Your ref  
APP/21/00979

Our ref  
PLAN-041984

**Proposal:** Two storey side extension and single storey rear extension and front porch.  
**Site:** APP/21/00979: - 19 Princes Drive, Waterlooville, PO7 7QN.

Southern Water MapGuide Browser

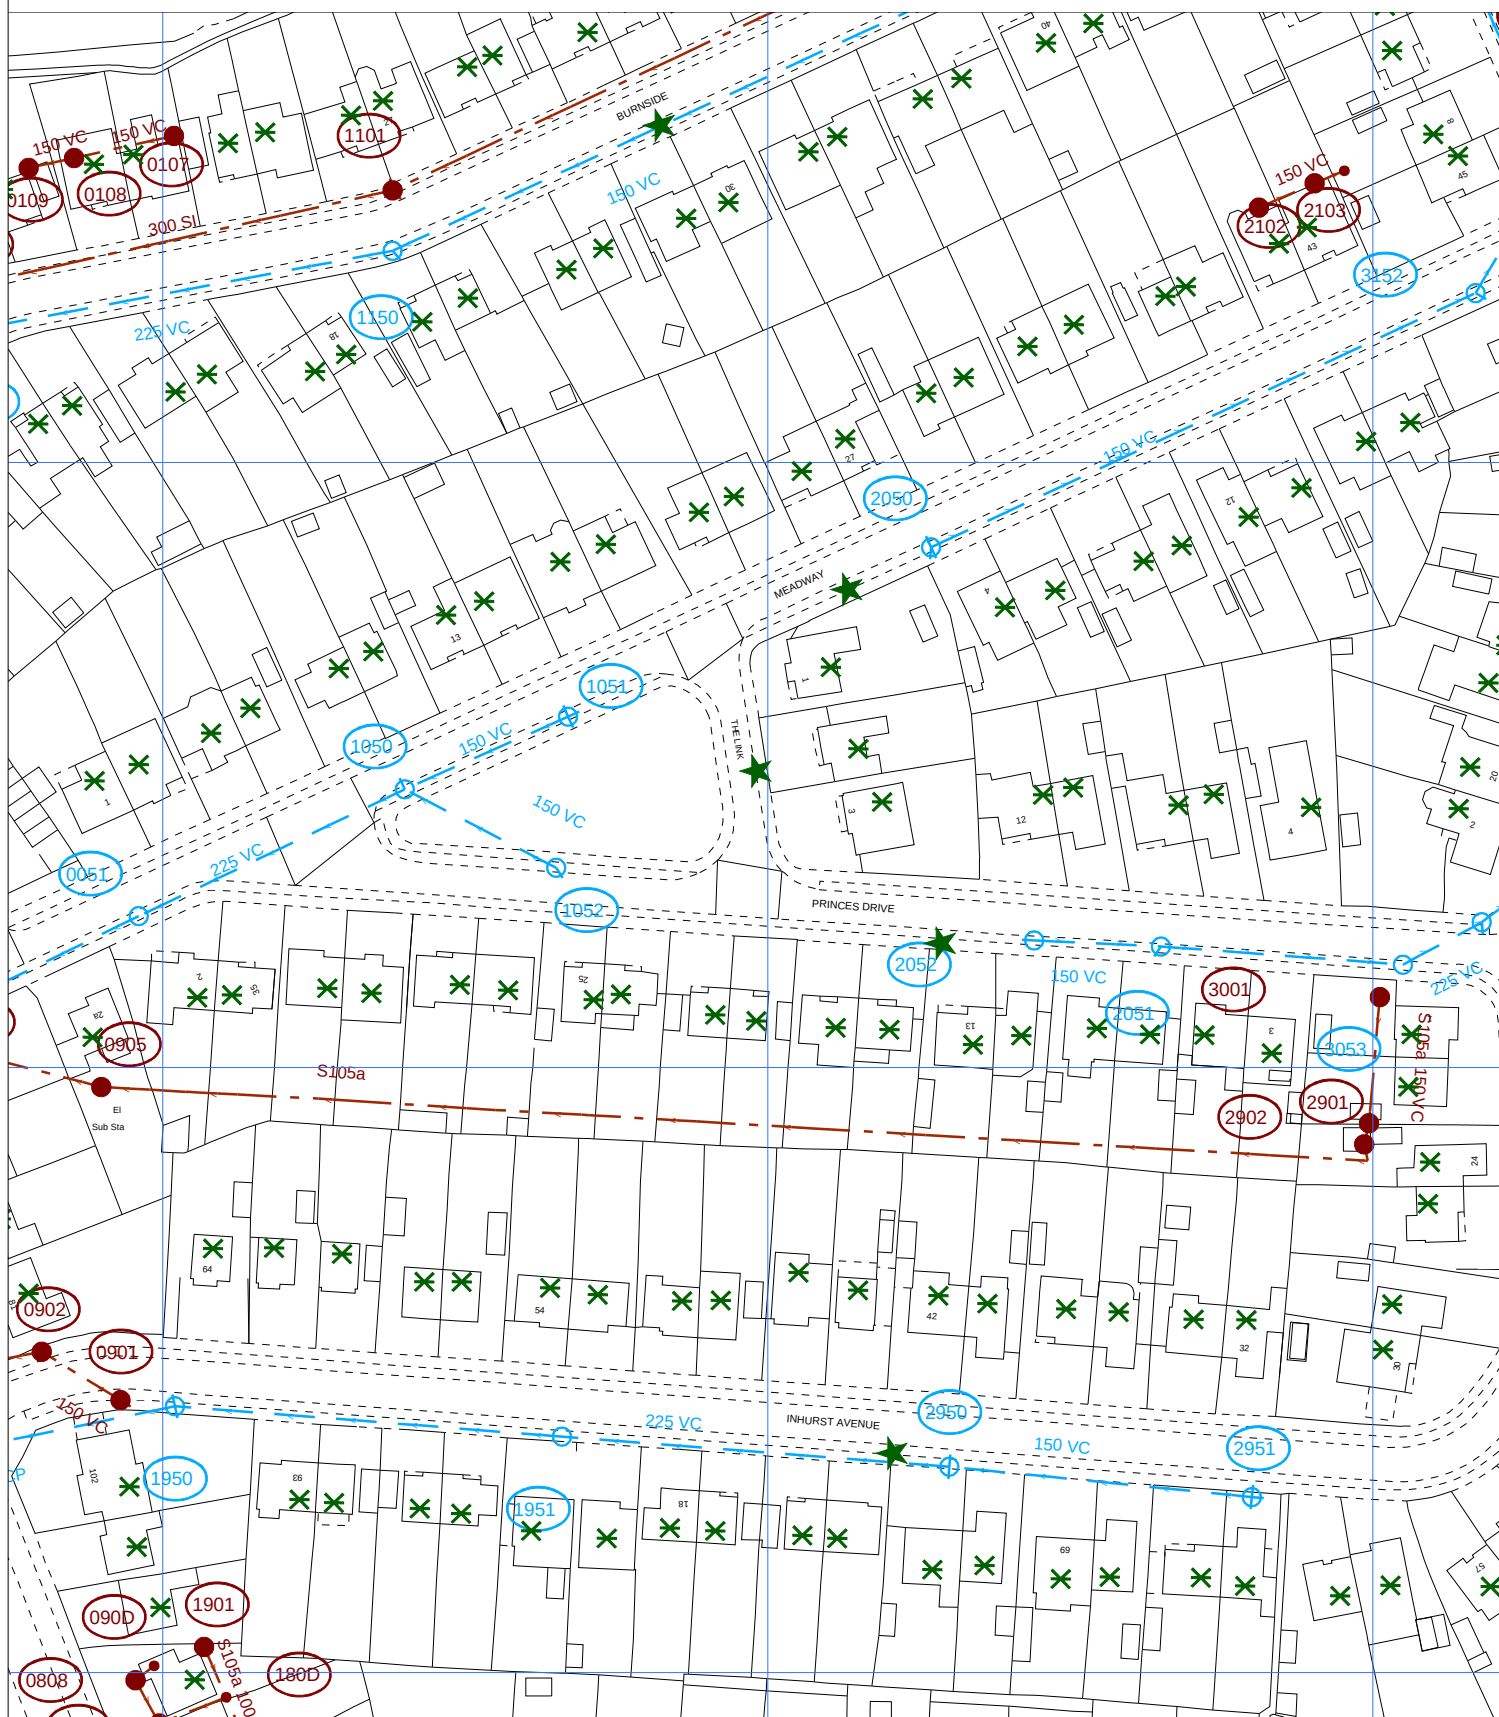
It appears that the developer is intending to build-over a public foul sewer which is crossing the site. Building over a "public sewer" is not normally permitted by Southern Water. An investigation of the sewer is required to confirm its size and depth, ascertain its condition, number of properties served and potential means of access before any decision can be made as to whether it would be acceptable for Southern Water to allow building-over/close-to the sewer.

Furthermore, it is possible that a sewer now deemed to be public could be crossing the development site. Therefore, should any sewer be found during construction works, an investigation of the sewer will be required to ascertain its ownership before any further works commence on site.

'In order to protect drainage apparatus, Southern Water requests that if consent is granted, the following condition is attached to the planning permission; Prior to the commencement of development, the developer must advise the local authority, in consultation with Southern Water, of measures which will be undertaken to protect the public sewers.
